Expert Opinion

Amendment C391 to the Greater Geelong Planning Scheme

Panel Hearing

Report Author:	Warwick Bishop
Title:	Expert Opinion Report
Location:	87-127 Ash Road, Leopold
Report Prepared For:	Eastern Ash Pty Ltd
Instructed By:	Maddocks
Panel Hearing:	Amendment C391 to the Greater Geelong Planning Scheme
Date of inspection:	05 November 2021
Date of Report:	15 November 2021
Document Name:	22010131_R01_v01c.docx

Figure 6-7 Development Layout (Tract, October 2020)

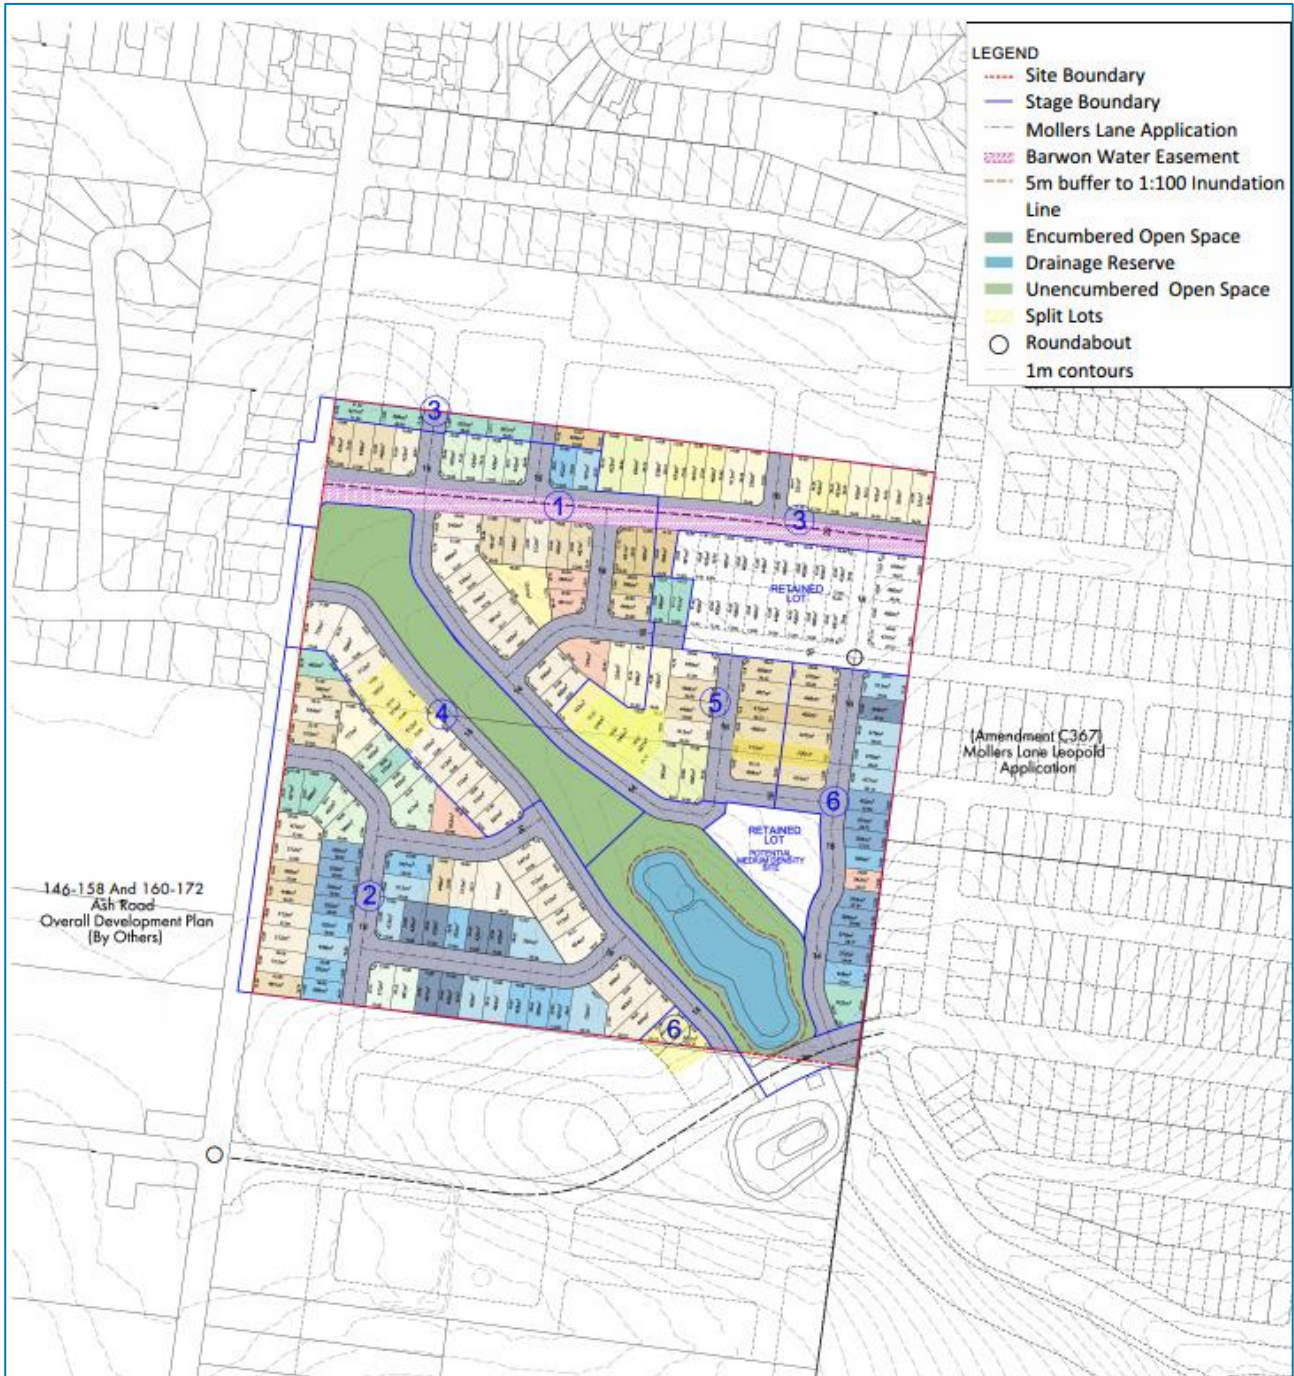
It must be noted that it is not uncommon for proposed concept site layouts to change as the development progresses. Net Developable Area increases by about 0.7 ha in the revised subdivision layout. This increase in imperviousness area would need to be catered for in the design of the pipes and drainage assets.

The SMP (further discussed in section 7) would need to be updated to confirm the size of water quality assets and retardation basin in light of the proposed changes in landuse (i.e., fraction imperviousness)¹. Given that the overall density is not significantly altered, I do not anticipate that the changes will have a significant impact on the design of the drainage and water quality assets. That is, the location and general configuration of the retarding basin/wetland will not change and any alterations to the detailed design and sizing would be minor.

Figure 7-2 Frog Habitat & Stormwater Wetland Design²

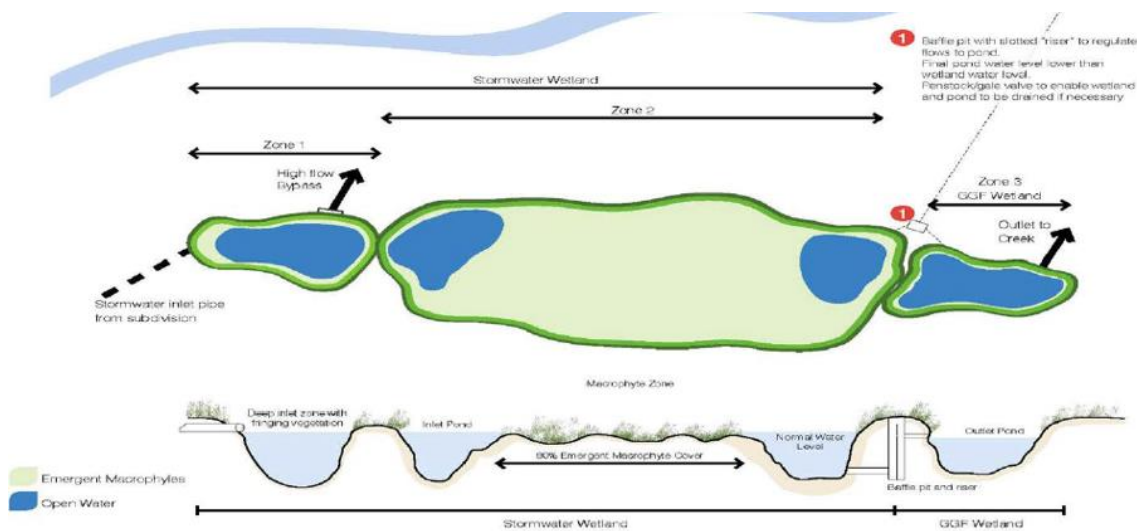
- I consider that the proposed water quality treatment train (i.e., constructed wetland) is appropriate to meet Best Practice objectives. I note that the [Infrastructure Design Manual](#) and VPP refer to the BPEMG objectives.
- I note that DELWP, in their submission to the panel, recommend an amendment to draft permit condition 17, to include design standards that meet Growling Grass Frog Habitat Design Standards in any new WSUD landscape elements. This has not been considered in the SMP however, it would be appropriate for this to be considered at the functional/detailed design stage:
 - The wetland design can be adjusted to integrate Growling Grass Frogs (as shown in Figure 7-2), noting this may increase the footprint of the asset and, possibly, encumbered land.

Figure 7-3 Pre- and Post-Comparison Map January 1935 (Source: Venant Solutions, December 2019)

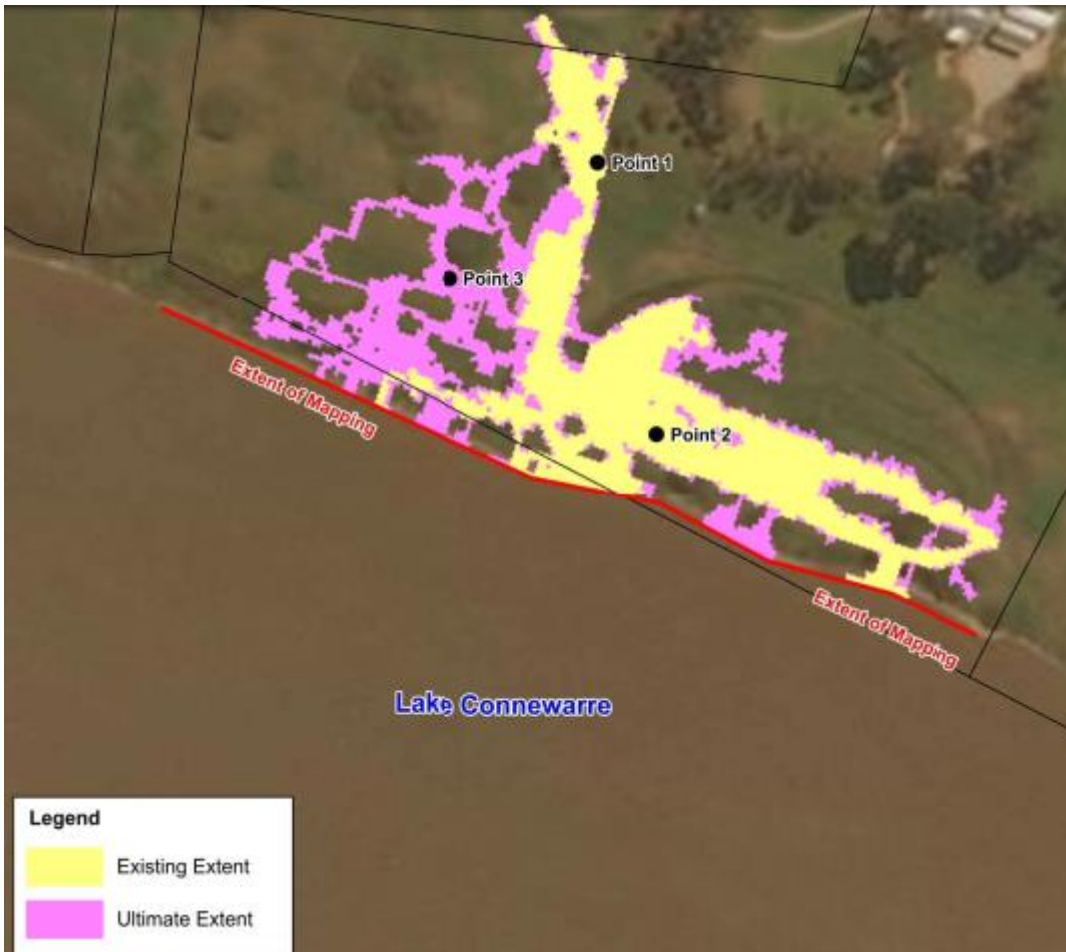
The post-development water balance modelling suggests that increases *in mean monthly runoff flows ranges from 76 % to 93 % with the increase fairly even across all months*. The hydraulic modelling also confirmed there would be an increase in inundation extent along the foreshore during the two months tested. The flood extent would increase by 0.22 ha in one of the scenarios tested (see Figure 7-3). There would be however, no significant change in the duration of inundation.

The report notes that the samphire and lignum habitat is in poor condition in the area affected by clearance, grazing and weeds (i.e., on private land) but much more extensive on the foreshore zone. It is inferred from this that the foreshore vegetation is composed of tolerant species and is likely to be resilient to the small changes in flow predicted. I am not in a position to comment on the vegetation response, however I note that in this localised area, the hydrologic impact is significant.

The Venant Solutions report acknowledges that these changes are likely to lead to significant changes to water quality or ecology of the foreshore habitat in a small area (of approximately 0.5 ha) adjacent to Lake Connewarre. On the other hand, and relative to the overall Ramsar size, the predicted changes would represent a low risk to the Ramsar wetlands.

Figure 10-1 1% AEP Flood Afflux (source: Spiire, February 2020)

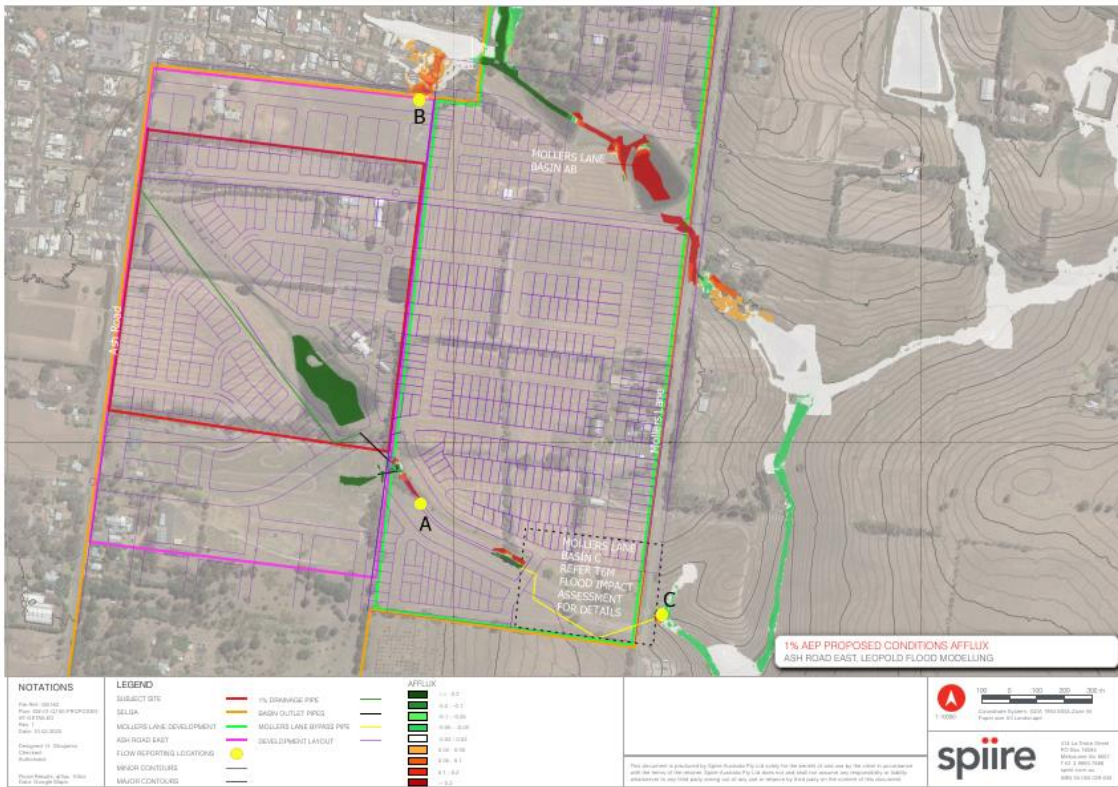
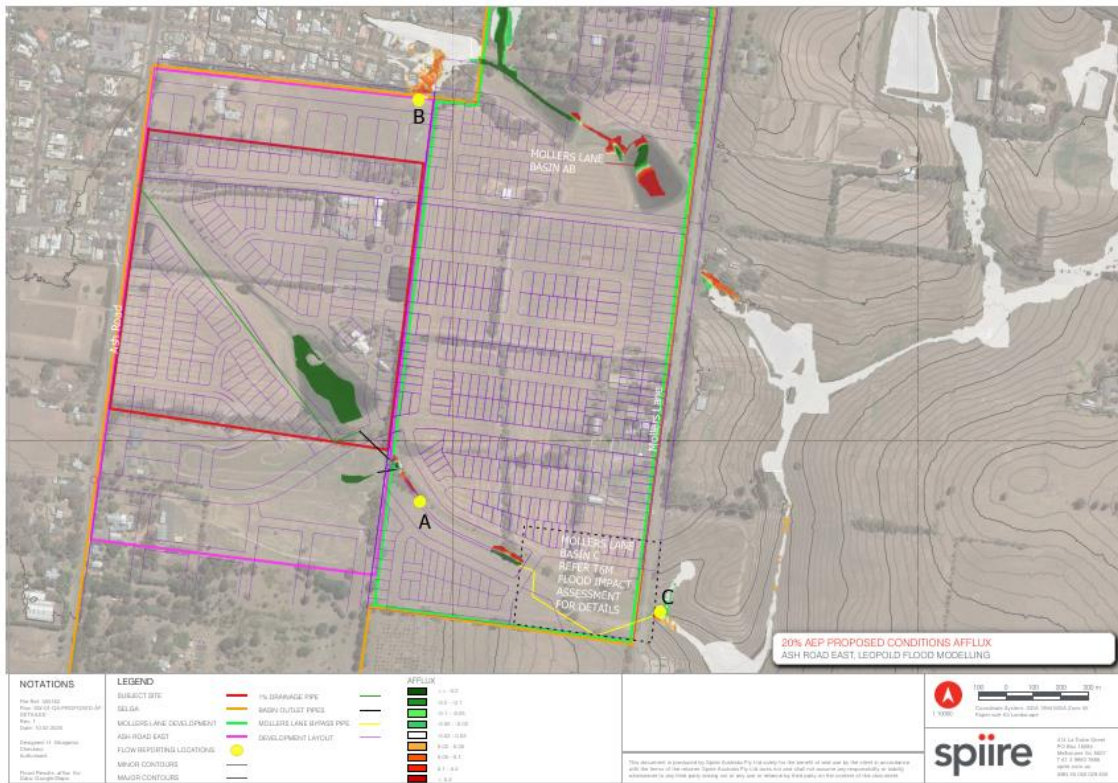
<p>Submissions 10, 17 - Detrimental impact on adjacent land, which are not mitigated by the proposed drainage infrastructure proposed in the Stormwater Management Plan (Spiire, February 2020).</p>	<p>The modelling to-date, which includes a range of events, provide confidence that the potential adverse impacts can be mitigated as part of the detailed design. The hydraulic modelling shows some increase in flood levels (i.e., afflux) on adjacent properties. This afflux is generally contained within drainage and waterways reserves and/or road reserves (as shown in Figure 10-1 and Figure 10-2).</p> <p>It is desirable that a flood impact analysis be undertaken over a range of design flows, not just the extreme flood range. Whilst a range of events were modelled, impacts from the development was only assessed for the 20% and 1% AEP events. I expect the afflux information could be readily extracted for other events (e.g., 50% AEP) from the model results.</p> <p>I consider the critical aspect for the impact assessment at the planning stage is to determine whether feasible mitigation strategies exist to mitigate those impacts identified by the modelling. The results presented in Spiire's SWMP, and Corangamite CMA "no objection" position, provide confidence that mitigation solutions</p>

Concerns Raised	Comments
	<p>can be achieved for the development. The details of which will be finalised as the project design progresses and could be addressed in the SWMP to be submitted to Council with the detailed design. In the case where some residual afflux above acceptable limits remains (e.g., that may change, affect or limit the future development potential of adjacent properties), the design solution can be refined and resolved through the detailed design process in compliance with Council's and Corangamite CMA's requirements. Some level of residual afflux could also be discussed with and accepted by the relevant authority or any affected property owners.</p> <p>I note that Council, in its response to the submissions, indicated that <i>the proponent will be required to further quantify the impact and amend the SWMP to demonstrate how this will be mitigated</i>. A number of conditions (e.g., # 4, #6, #17) are included in the draft planning permit that would provide suitable control to ensure additional details (and other clarifications required in the SWMP) are provided, prior to Certifications.</p> <p>I also note that proposed infrastructure to service the areas not covered by the planning permit application is conceptual only. This will need to be confirmed by the proponents for these parcels, as part of future planning permit application. The information provided in Spiire's SWMP provides suitable confidence that the overall C391 can be serviced once developed, though details may need to be refined for the other parcels. I would anticipate that site-specific Stormwater Management Plans would be prepared, to support other future planning permit application(s).</p>
